**Fenwick Solar Farm
EN010152**

**Landscape and Visual Supplementary Report
Document Reference: EN010152/APP/8.23**

- 1.1.1 Iceni Projects (Iceni) have prepared this Landscape and Visual Supplementary Report in response to the Relevant Representation made by City of Doncaster Council (CDC) **[RR-001]** (CDC's Relevant Representation) in relation to the proposed Fenwick Solar Farm (the Proposed Development). This was informed by a review of the Landscape and Visual Impact Assessment (LVIA) which was carried out by LUC on behalf of CDC.

PROJECT

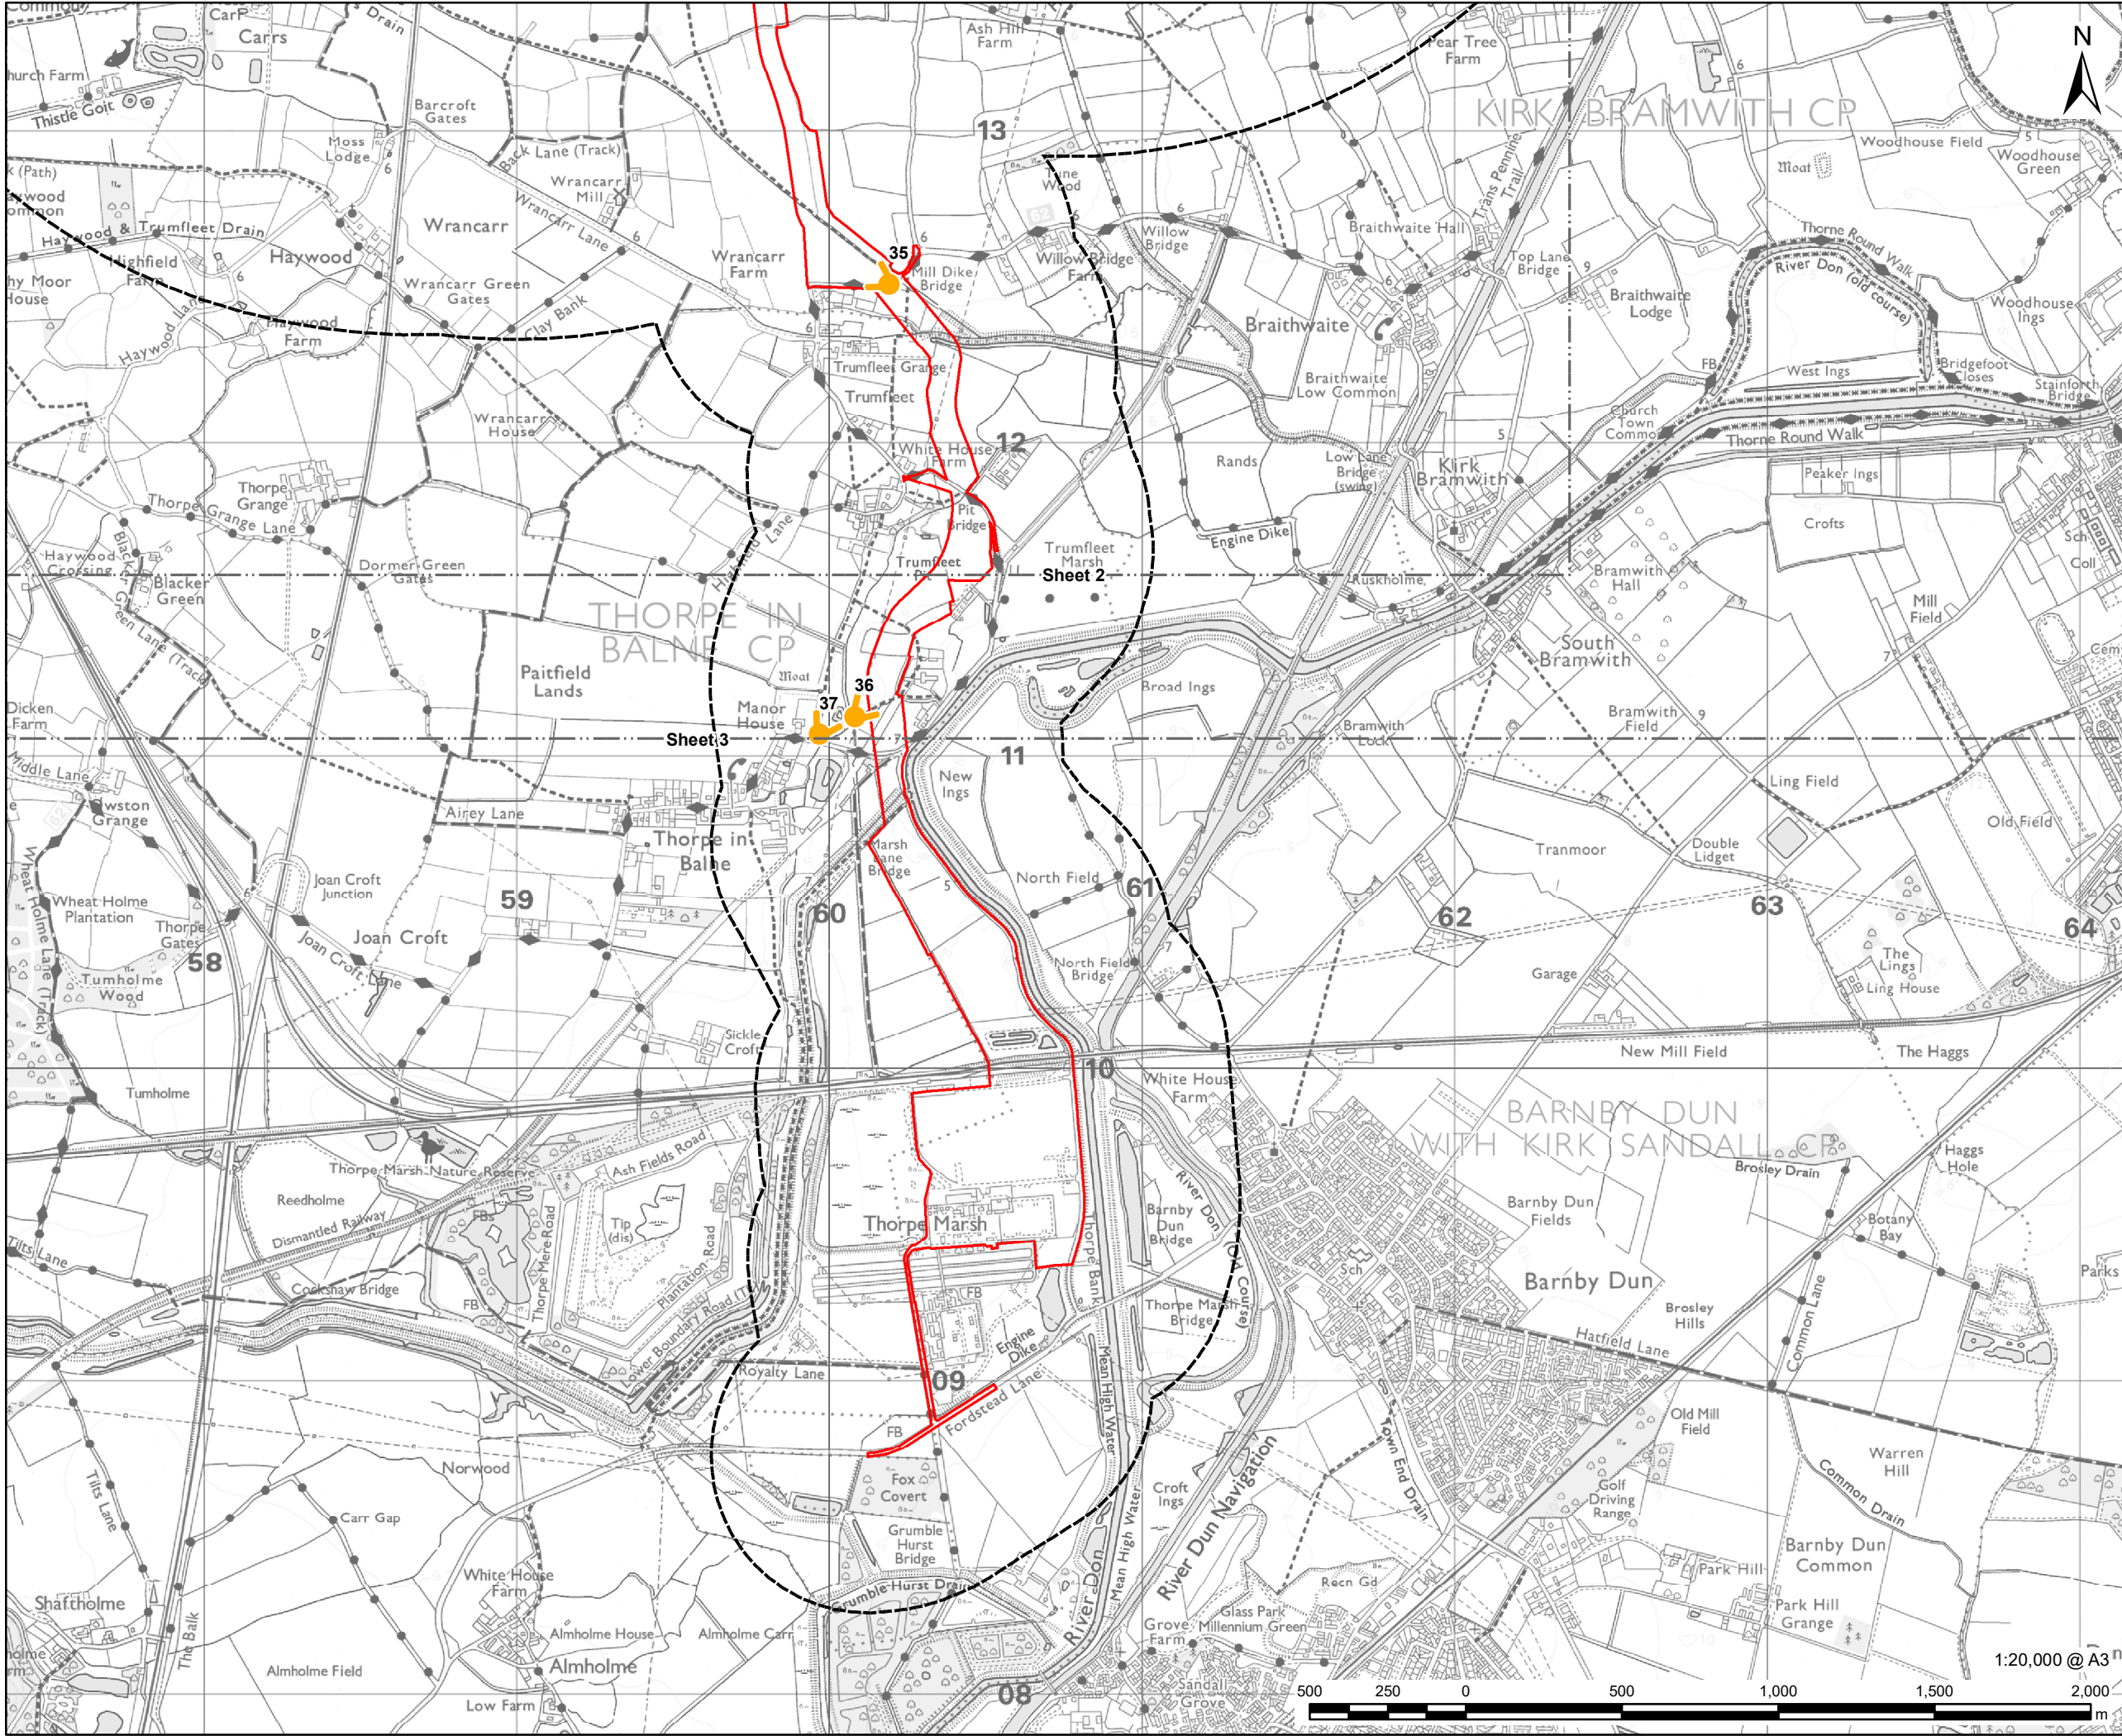
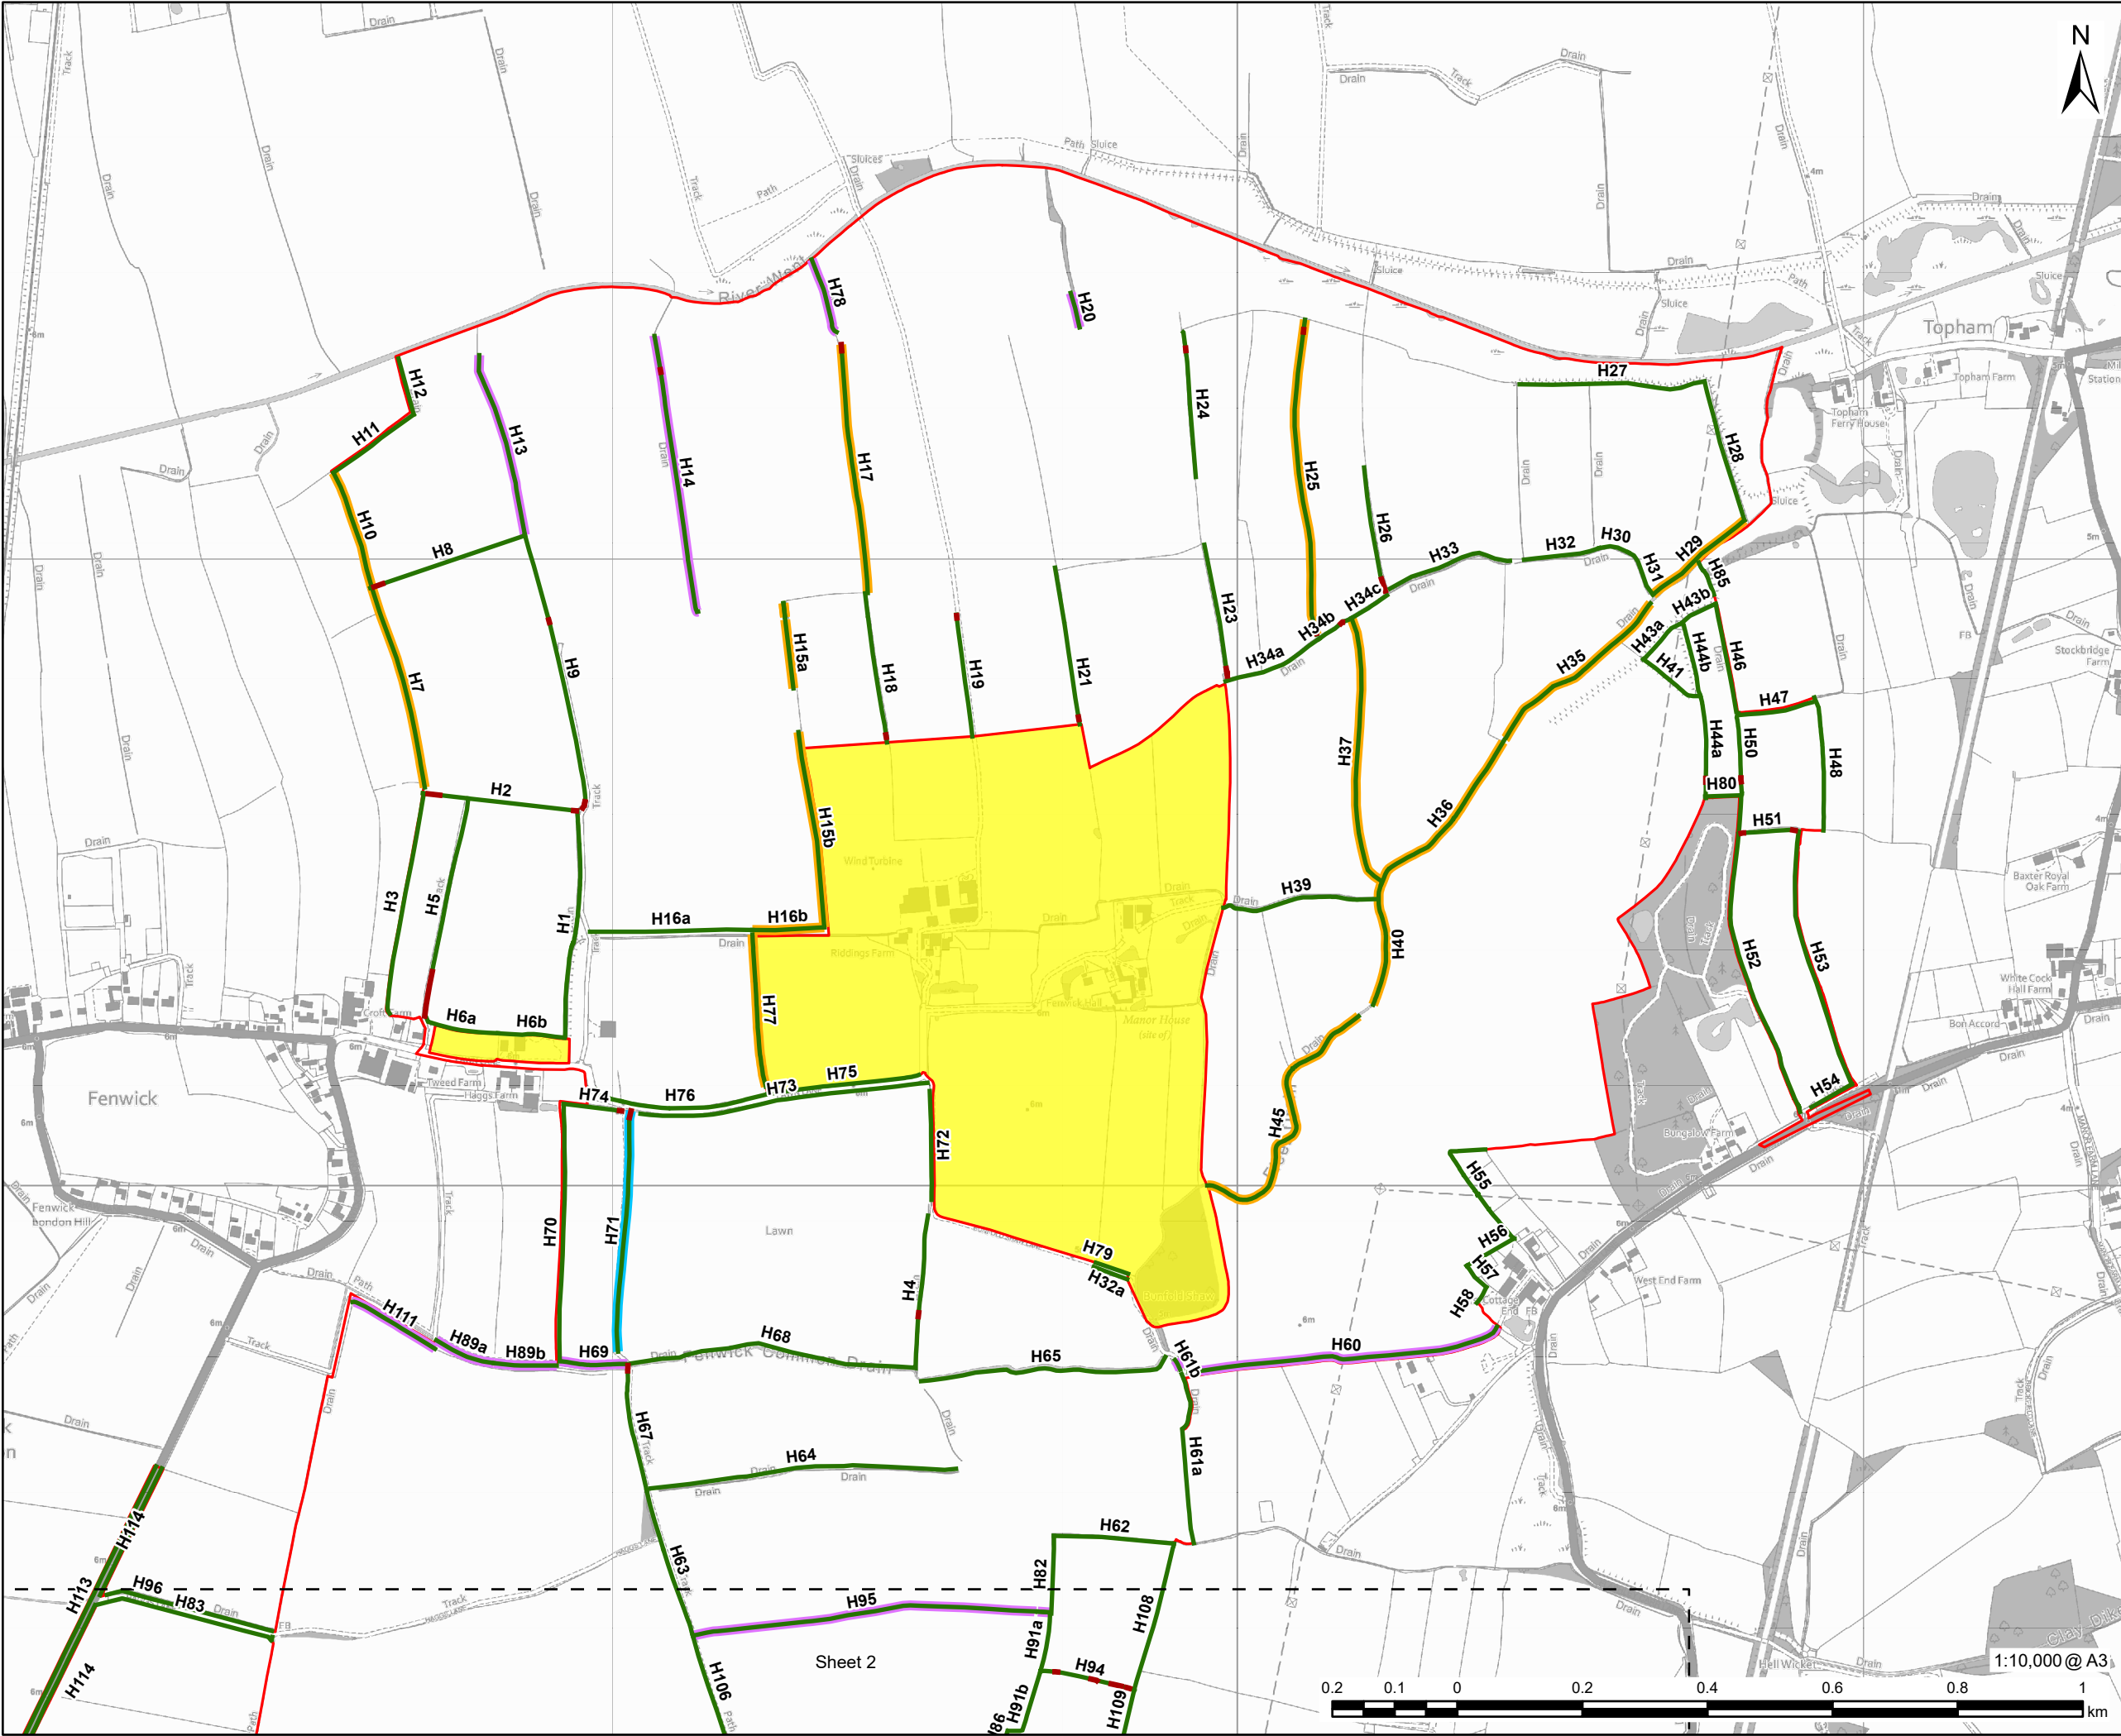
- Updated representative viewpoint plan (**ES Volume II Figure 10-9: Representative Viewpoint Locations [APP-111]**) with clearer base mapping;
- Detail of updates to be made to the Zone of Theoretical Visibility (ZTV) (**ES Volume II Figures 10-6 – 10-8 [APP-108 – APP-110]**);

- 2.1.4 An updated representative viewpoint plan has been provided within **Appendix A**. This has been split across four sheets, using 1:25,000 OS base mapping. The 1:25,000 OS base mapping does not yet show the new properties along Fenwick Common Lane / Shaw Lane. However, these are included on the 1:10,000 mapping used as thumbnails to present the location of each representative viewpoint alongside the updated viewpoint photography photosheets (to be provided in early to mid-May).
